Access Compliance Report

Public Rights-of-Way

Intersection ID: 32317	Main Street: BRIDGEVIEW_LN	Cross Street: NEW_PROVIDENCE_LN	Location: NE
ADA ID: 8C417C1FE347	Ramp Type: PerpDiag	Initial Pass/Fail: Fail	Overall Compliance: No
Severity Score: 33.75			
Codes/Mitigation Info/Possible Solution		Field Measurements/Component Compliance

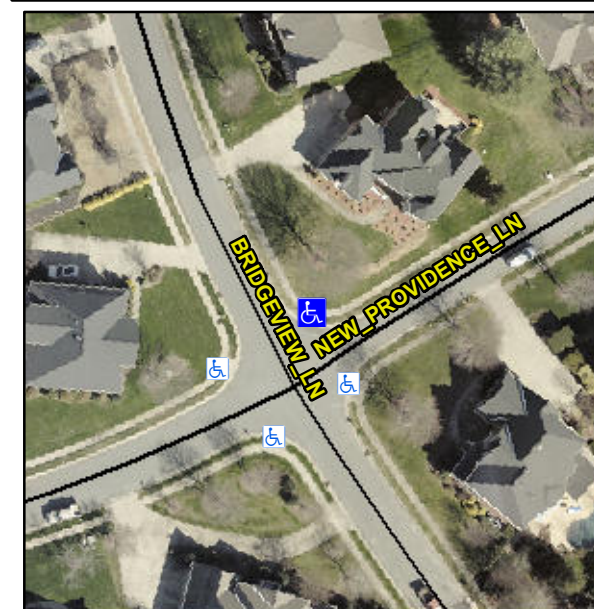
Not Found, R304.5.1, R304.2.2, R304.5.3

Compliance	Description	Data	Compliance	Description	Data
N/A	Ramp Length (in)	46.5	No	Ramp Slope (%)	8.4
No	Ramp Width (in)	43.0	No	Ramp XSlope (%)	6.7
N/A	Flare Type LT	N/A	N/A	Flare Type RT	N/A
N/A	Flare Slope LT (%)	N/A	N/A	Flare Slope RT (%)	N/A
N/A	Flare Traversable LT?	N/A	N/A	Flare Traversable RT?	N/A
N/A	Landing Length (in)	N/A	N/A	DWS Provided?	N/A
N/A	Landing Width (in)	N/A	N/A	DWS Contrast?	N/A
N/A	Landing Slope (%)	N/A	N/A	DWS Length (in)	N/A
N/A	Landing X Slope (%)	N/A	N/A	DWS Full Width?	N/A
N/A	Landing Curb? (Y/N)	N/A	N/A	DWS Offset (in)	N/A
N/A	Shared Landing?	N/A			
N/A	Gutter Ponding?	N/A	N/A	Gutter Slope (%)	N/A
N/A	Gutter Lip Ht (in)	N/A	N/A	Gutter X Slope (%)	N/A
N/A	Painted X Walk1?	No	N/A	Painted X Walk2?	No
	X Walk 1 Direction	To SW		X Walk 2 Direction	To SE
N/A	X Walk 1 Width (in)	N/A	N/A	X Walk 2 Width (in)	N/A
	X Walk 1 Slope (%)	1.4		X Walk 2 Slope (%)	6.6
	X Walk 1 X Slope (%)	7.6		X Walk 2 X Slope (%)	0.1

Remove & Replace Curb Ramp With Two New Directional Ramps or Equivalent.
